Re: Response to Comments on Peer Review for  
Leicester Central, 0, 90, 92 Huntoon Memorial Highway

On behalf of JMC/TBG Leicester, LLC (the "Applicant"), VHB is pleased to provide the following responses to the comments/questions raised in the Peer Review Letter prepared by Quinn Engineering, Inc. dated January 4, 2022 regarding the proposed Leicester Central Development (the "Project").

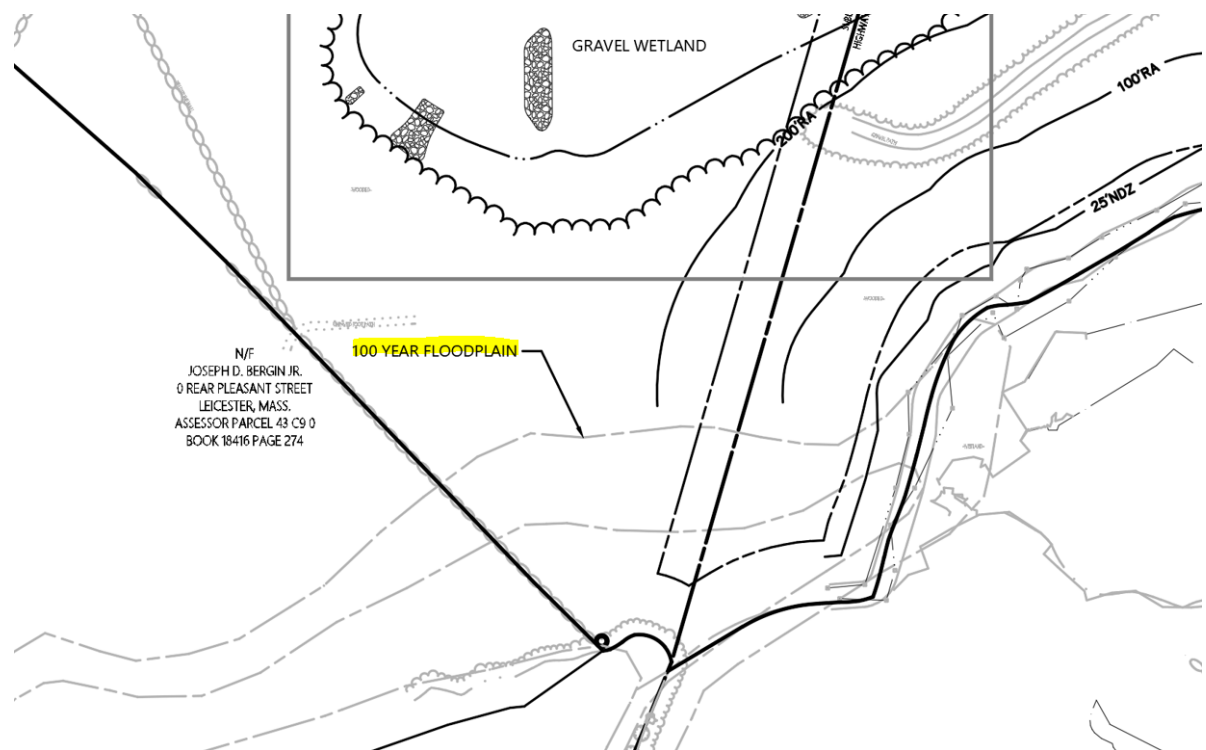
Comment 6. *"Plans should identify the status of the site in relation to flood plain. If flood plain exists onsite, it should be identified on the plan."*

**Response:** There is a small area of 100-year floodplain located on the Site within the most southerly corner where Grindstone Brook enters Rochdale Pond. The line is well outside the limit of work so it does not show up on the detailed plan sheets, however it is visible on Sheets C2.00 & C4.00 but is not labeled. VHB has added a label to clearly identify the 100-year floodplain on those sheets.
